Agenda Item # 6

SUB-003824-2026

CWorks

CWORKS OPERATING SUBDIVISION

DETAIL SITE PLAN

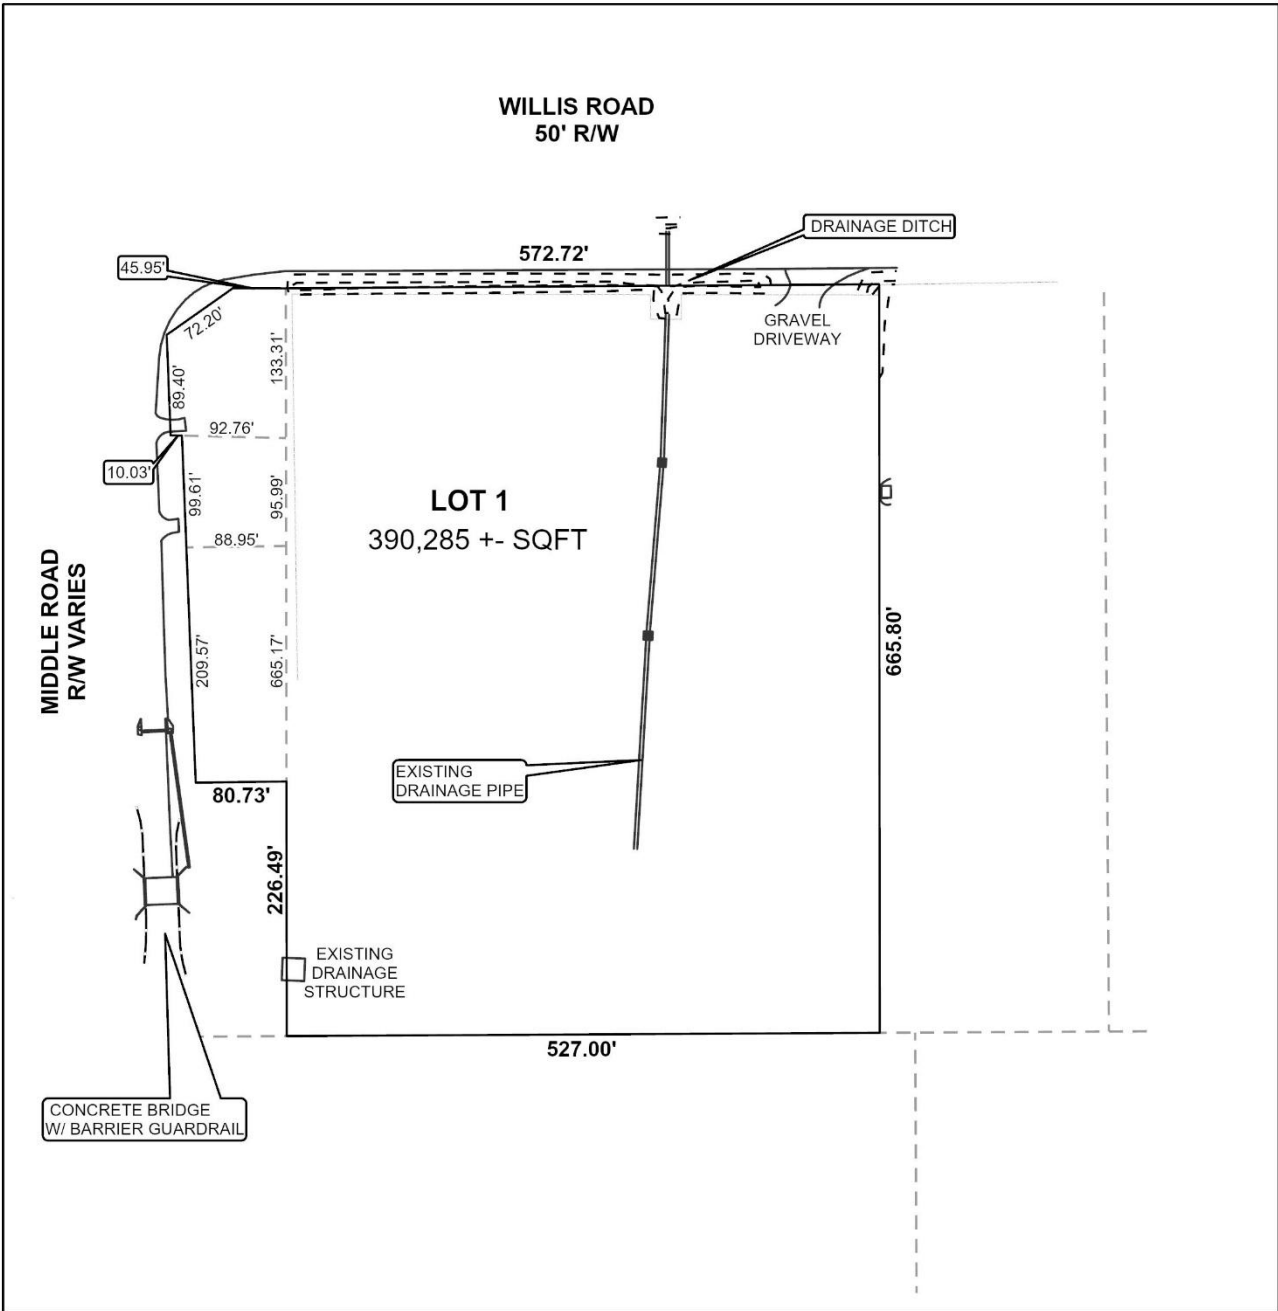
The lot fronts Willis Road and Middle Road. Both are minor streets without curb and gutter, each requiring a 60-foot right-of-way width. The preliminary plat illustrates a 50-foot right-of-way width along Willis Road and a varying right-of-way width along Middle Road. If approved, the Final Plat should be revised to illustrate dedication of 30-feet from the centerline of both Willis Road and Middle Road.

The plat should be revised to depict the existing corner radius at the intersection of Willis Road and Middle Road and, if the radius is less than 25 feet, provide sufficient dedication to achieve a 25-foot radius, in compliance with Section 6.C.6. of the Subdivision Regulations.

The preliminary plat does not illustrate front yard setbacks. If approved, the Final Plat should be revised to illustrate 25-foot minimum front yard setbacks along both Willis Road and Middle Road.

1. Dedication to provide 30 feet from the centerline of Willis Road;
2. Dedication to provide 30 feet from the centerline of Middle Road;
3. Illustration of 25-foot minimum front yard setbacks along both Willis Road and Middle Road;

4. Revision of the plat to provide the existing corner radius at the intersection of Willis Road and Middle Road and, if less than 25 feet, dedication sufficient to achieve a 25-foot corner radius;
